## NOTICE OF VIOLATION

On March 25, 2025, Energy Safety conducted an inspection of SDG&E's WMP initiatives in the vicinity of the city of Alpine, California. The inspection report is enclosed herewith. Energy Safety found the following violation:

# INSPECTION REPORT

Item1GImg1: Overall pole	Item1GImg2: Pole ID

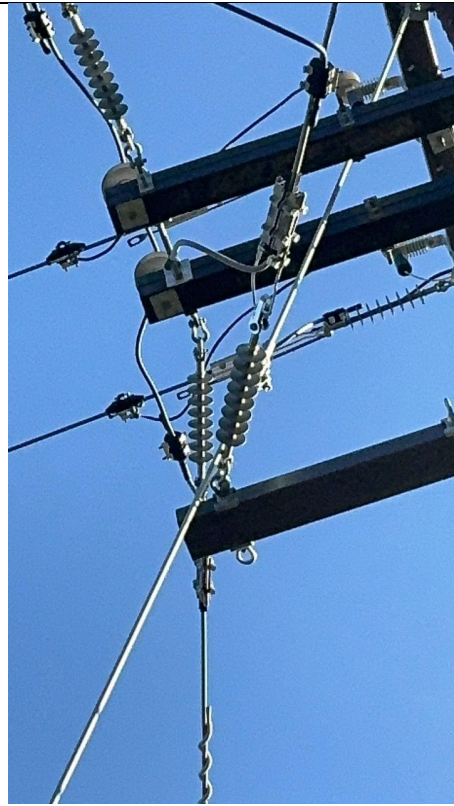
On pole ID P275777, Grid Hardening ID P275777\_0073-R-CC\_4102 at Alpine, CA, coordinates 32.760862481866, -116.688413323077, the inspector observed an excessively loose down guy wire fiberglass strain insulator in contact with a dead-end suspension insulator. The dead-end suspension insulator supports a 12 kV primary phase conductor. The inspector's observation is documented in Violation 1 photographs, which are attached to this report. Photo numbers Item1IA1Img1, Item1IA1Img2, Item1IA1Img3 and Item1IA1Img4 depict a fiberglass strain insulator in contact with a suspension dead-end insulator between its skirts and the clevis or socket eye, which does not follow SDG&E's covered conductor installation standard. Per the 2024 4th quarter Quarterly Data Report, SDG&E indicated that the covered conductor work was completed at this location.

**Item1GImg4:** Down guy fiberglass strain insulator in contact with primary suspension dead-end insulator.

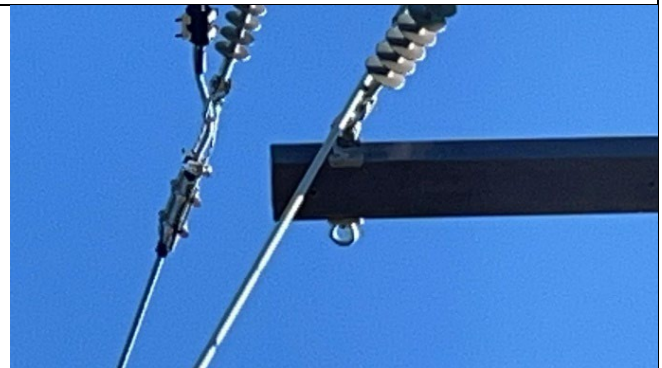
conductors supported on same pole, guys passing conductors supported on same pole must maintain a three-inch separation and the use of fiberglass strain insulators does not reduce this separation. The down guy wire fiberglass strain insulator is in contact with a suspension dead-end insulator and therefore does not meet the three-inch separation rule.
